Re: Darrow Road Townhomes

Darrow Road Townhomes Proposed Elevations

Subj: Staff Review Comments – S. Darrow Road Townhomes Case 21-1248

A. [AHBR 21-1248](#) Darrow Road Townhomes (Informal Review)

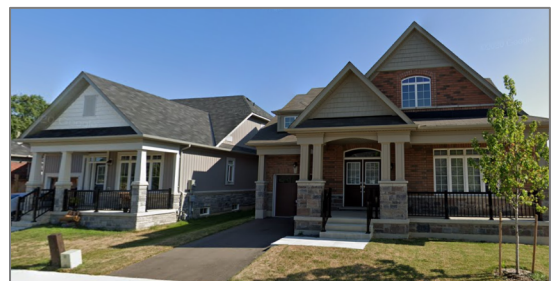
Staff notes the project was presented to the AHBR for informal review at the 1.12.22 AHBR meeting. During the meeting, significant discussion occurred on the placement of the garage doors relative to the front entryway. The Board concluded that aligning the front entryway and garage doors on the same elevation could be considered due to the location of the development and the significant setback from Darrow Road; however, making a recommendation is challenging without seeing a proposed elevation. Other discussion items included:

- Mix of colors and materials vs. a uniform building design
- Concern with the highly visible sides of buildings and questioning if some of the units should be turned towards the drive.
- Recommending fenestration be carried over to side and rear elevations.
- Concern of the overall appearance and presentation from the street and with the development feeling uninviting.

Kentlands, Maryland

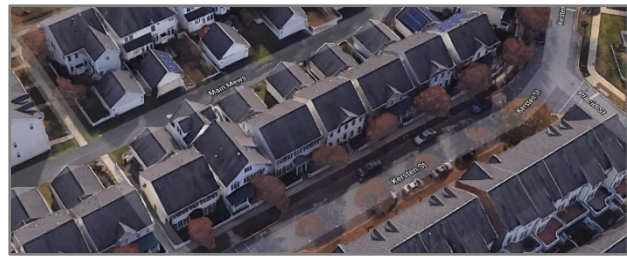
Staff Comment: Staff notes the intent of the regulation to minimize view of garages should be met by designing a more prominent/wider entryway and setting back garage doors/garage masses from the front face of the building.

Five Principles of Section I-2

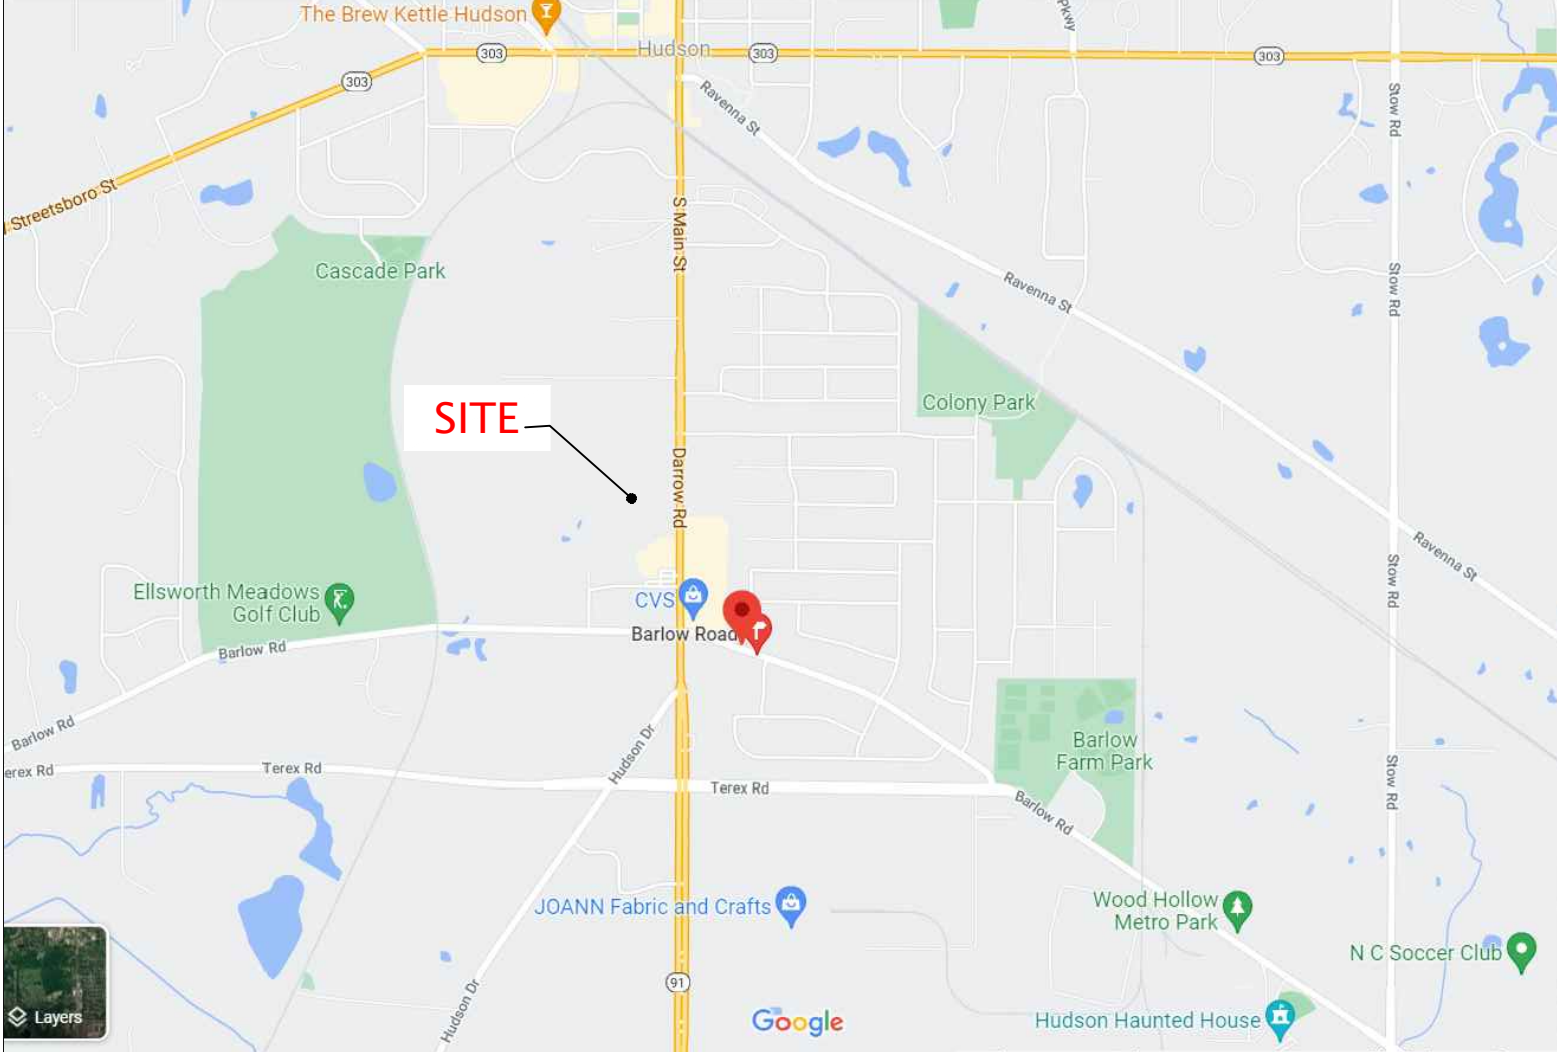
- Design Standard:** *No more than three primary materials may be used on any building.*
Staff Comment: Suggest a more uniform building design be implemented akin to previous iterations (see below). Variety could be achieved through the use of horizontal and vertical siding, accent materials, overall roof materials (metal vs. asphalt), window styles, garage door styles, overall building color, etc.

- Design Standard:** *To avoid long unbroken expanses of roof, roofs must be broken with cross gables, a change in roof height or orientation, or an offset of at least 18 inches.*
Staff Comment: Staff suggest each unit be broken up by varying roof heights to avoid a combined block appearance for units.

Staff Comment: After collective review of the above requirements, staff notes the applicant has not demonstrated exceptional design, nor a practical difficulty preventing the applicant from meeting all applicable design standards. The placement of (1) the garage doors facing the front, combined with (2) the garage doors begin forward of the main mass/door , and (3) the garage doors taking up the majority of the front façade all compound to significantly conflict with the Architectural Design Standards.
